AGENDA
BIRMINGHAM HISTORIC DISTRICT COMMISSION
WEDNESDAY – DECEMBER 15, 2021
BIRMINGHAM CITY HALL, 151 MARTIN ST., COMMISSION ROOM #205 *
******* 7:00 PM*******

SUBJECT: 320 Martin St. – Birmingham Post Office – Historic Design Review

BIRMINGHAM POST OFFICE ADDITION

SITE PLAN
SCALE: 1"=10'

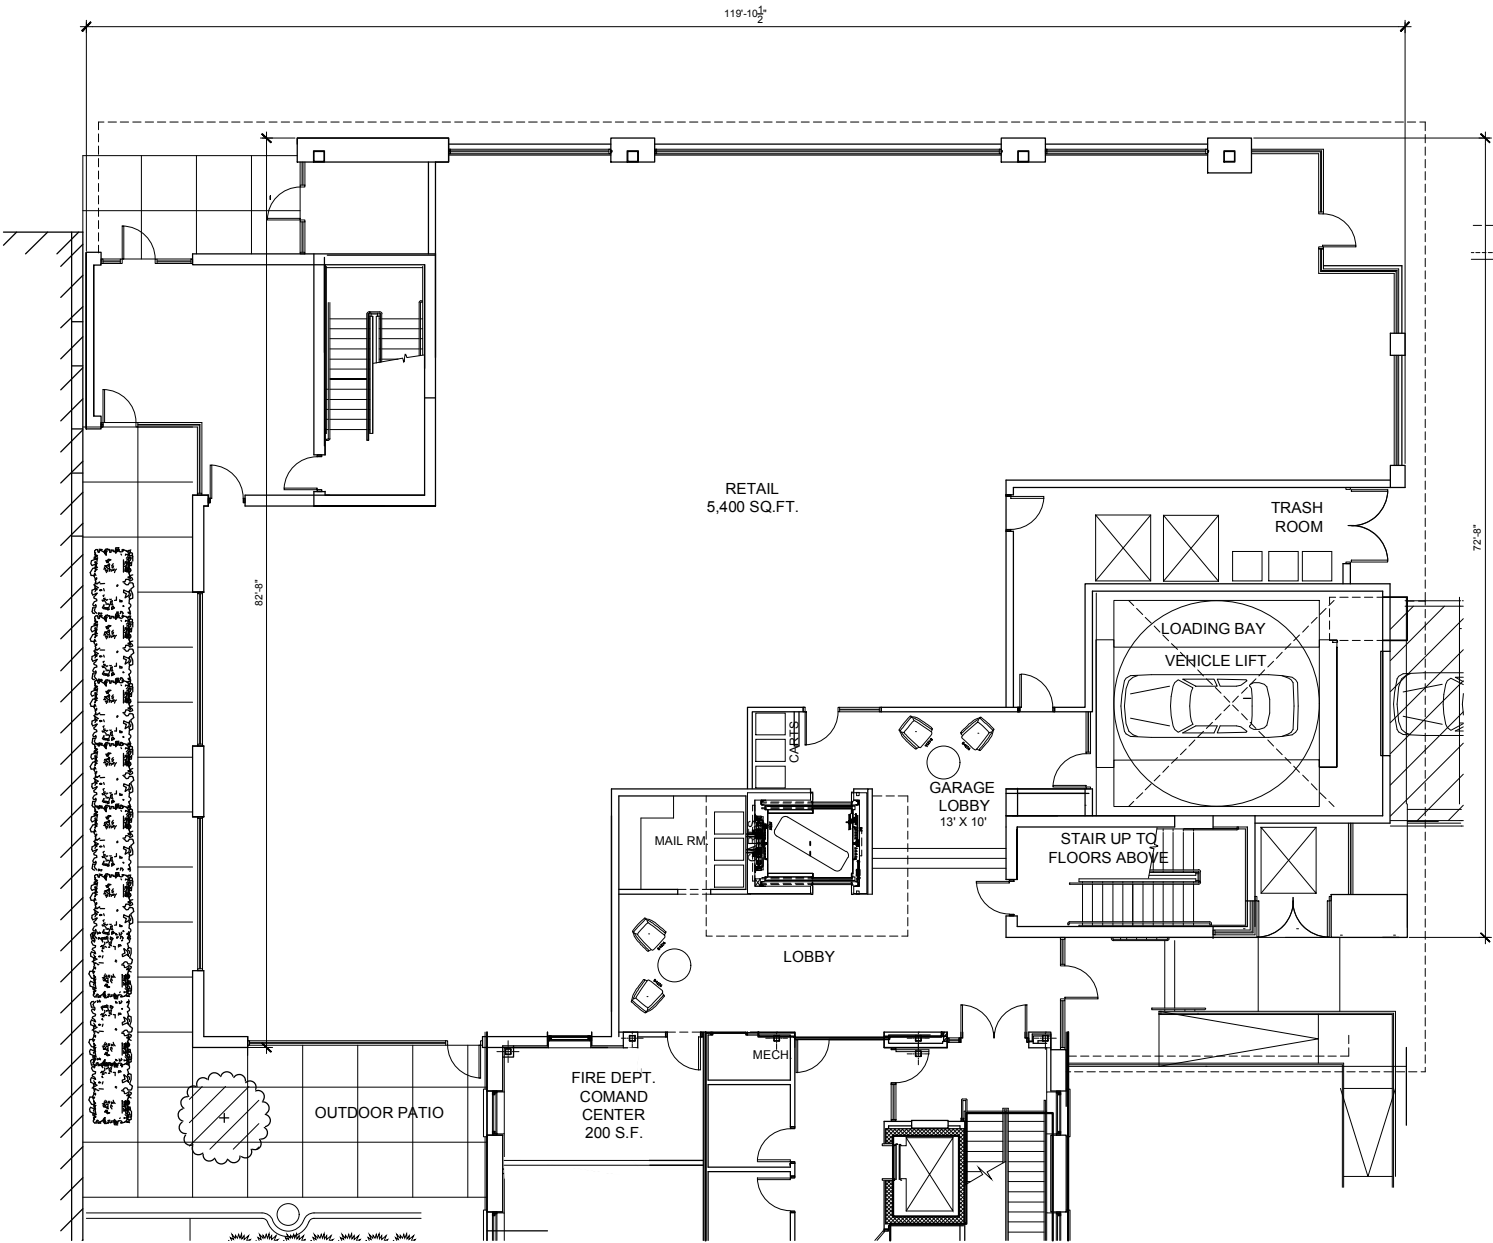
The rear of the building has changed over time with what appears to be the addition of a small lobby and some carports. The new proposal appears to remove this addition, but retain the historic portion to which the older addition is attached. The Planning Division does not feel as though the small lobby addition has retained any historic character.

A.201

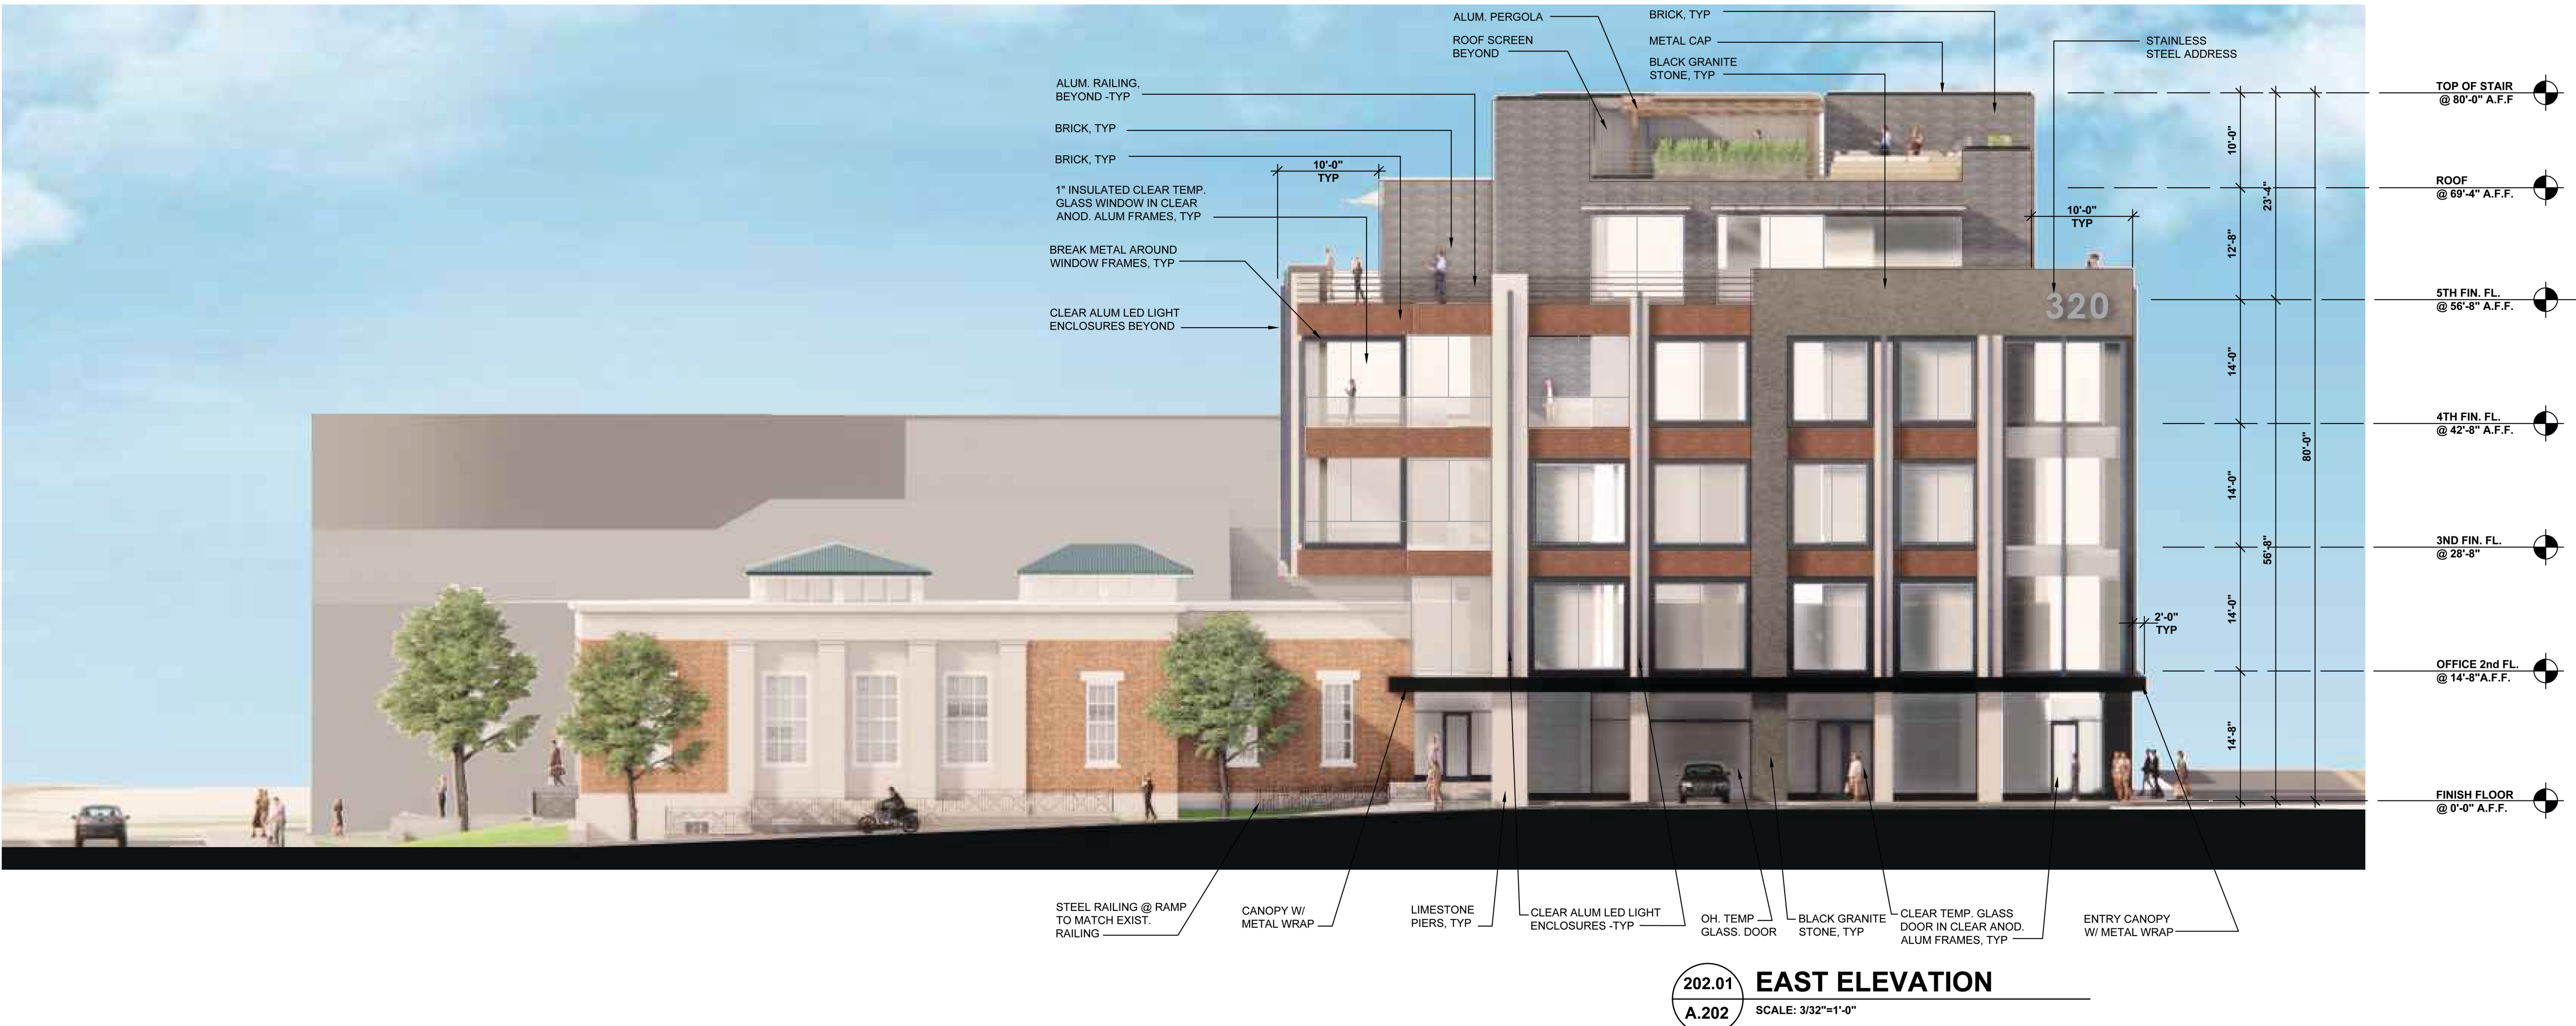
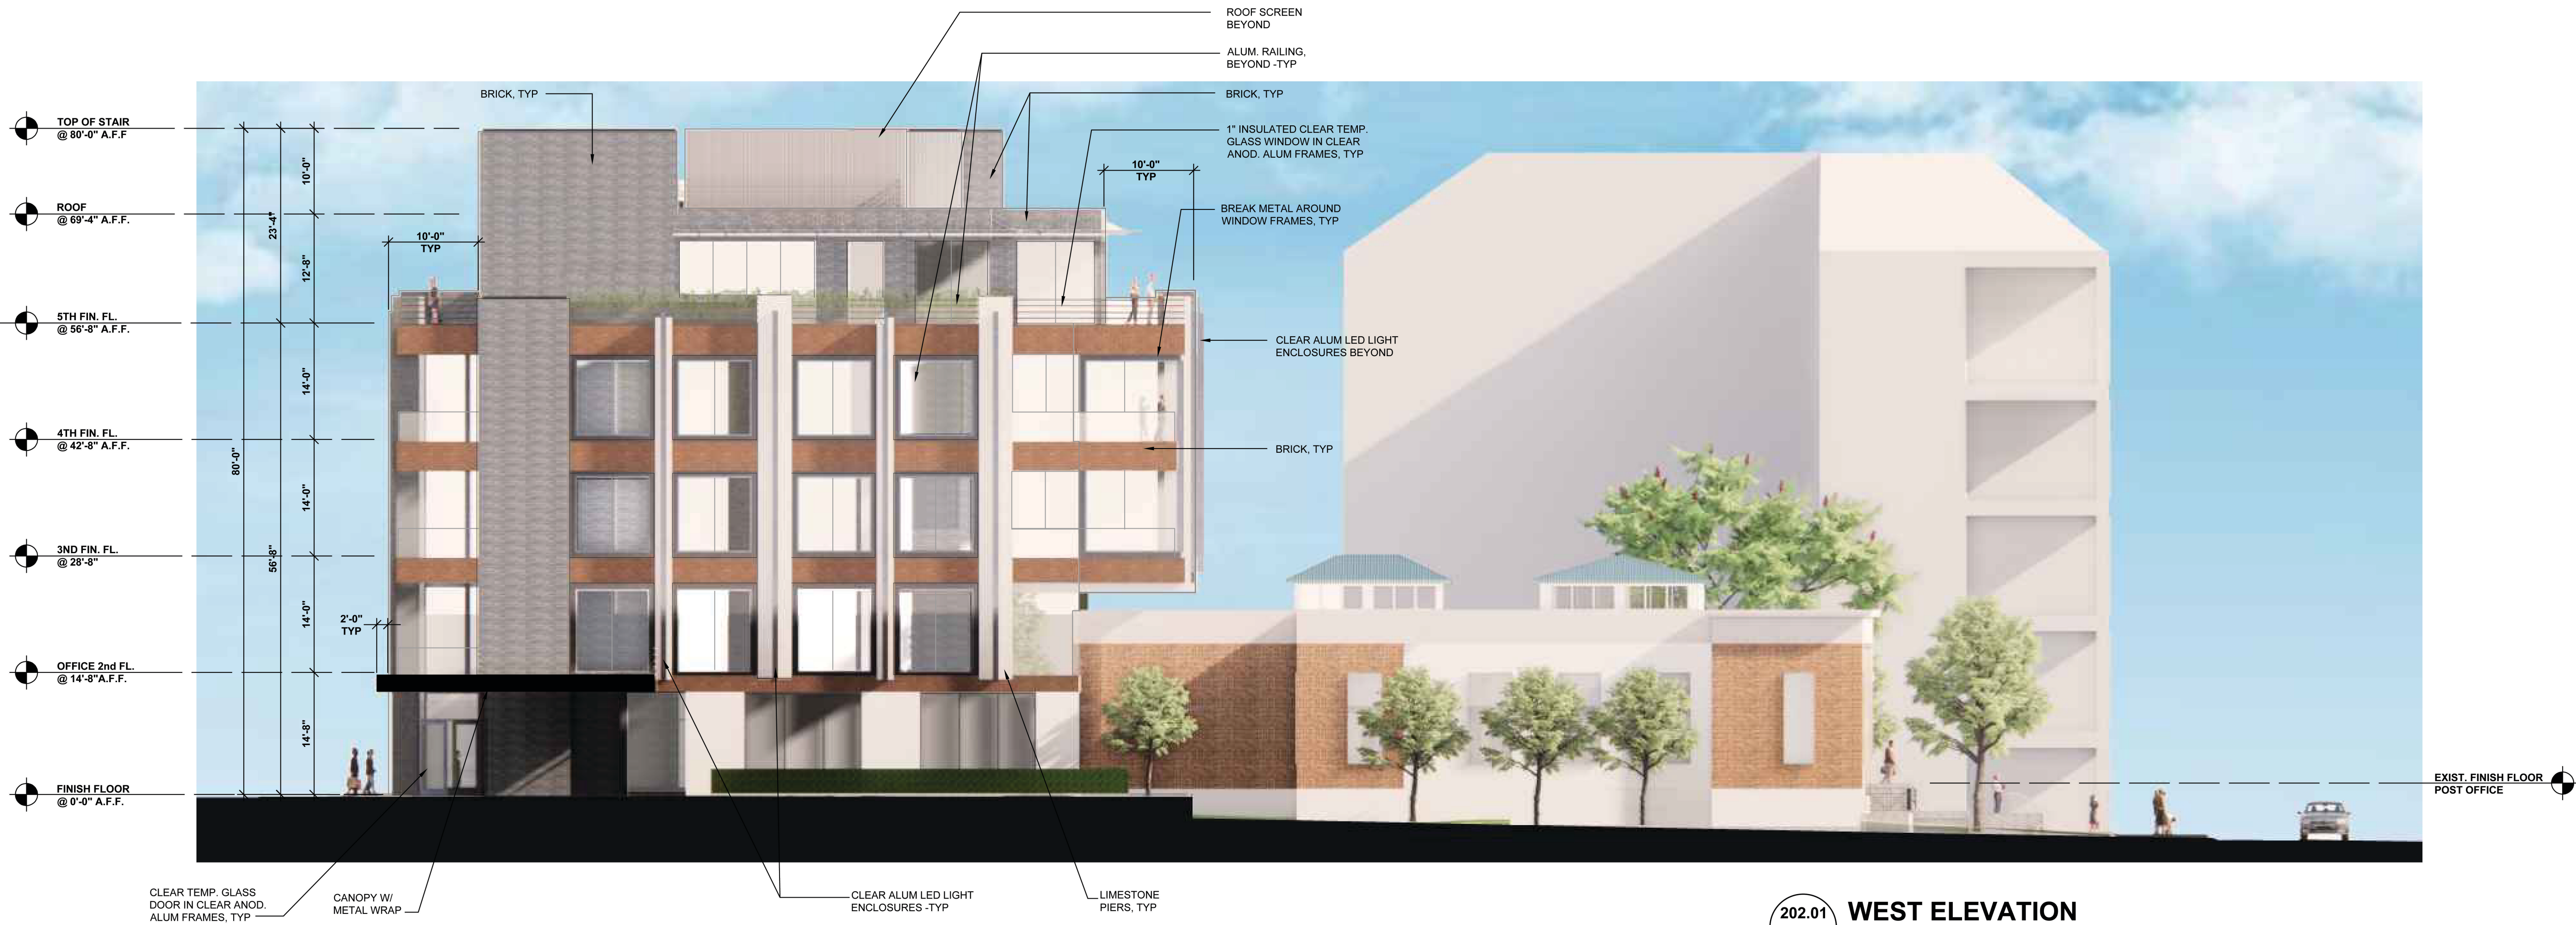
The placement of the new addition at the rear of the building, which has received treatments over the years itself, does not propose a removal of many historic materials, if any. Additionally, the character of the rear of the property is not as it was based on the original 1939 building. However, the important scale, massing, density conversation must be had here. Based on general guidelines, additions should be subordinate to the historic resource. Understanding the unique conditions of the site, and considering the properties frontage on 3 streets, a strict interpretation of the guidelines in terms of a subordinate addition would appear to mean a small, one-story addition. However, other guidelines suggest that there are ways to minimize the impact of larger additions onto historic resources by using a small hyphen to connect the two. However, this tact generally only works if the building is only slightly larger, say a 2 or 3 story building in this case. In the case of the Post Office building, a hyphen-like element already exists as a part of the original building, which may be used to soften the impact of the larger addition. In this case, the applicant appears to be taking away the advantage and impact of the natural hyphen by proposing a partial overhang over what would be considered the hyphen.

Similar to Standard #2, there appear to be minimal losses to historic materials on the rear of the Post Office. The new addition is certainly differentiated from the old, but may not match the massing, size, scale of the historic environment.

This standard appears to be met. However, it is worth noting that the proximity of the addition could pose a threat to the historic structure if there are any issues during a hypothetical future removal. In addition, the proposed underground parking must be handled with extreme care as to not disturb the historic structure and the ground beneath it.

Based on the review above, the Planning Division recommends that the Historic District Commission **POSTPONE** the Design Review application for 320 Martin St. – Birmingham Post Office – to give the applicant time to address the Secretary of the Interior Standards for Rehabilitation numbers 2 and 9.
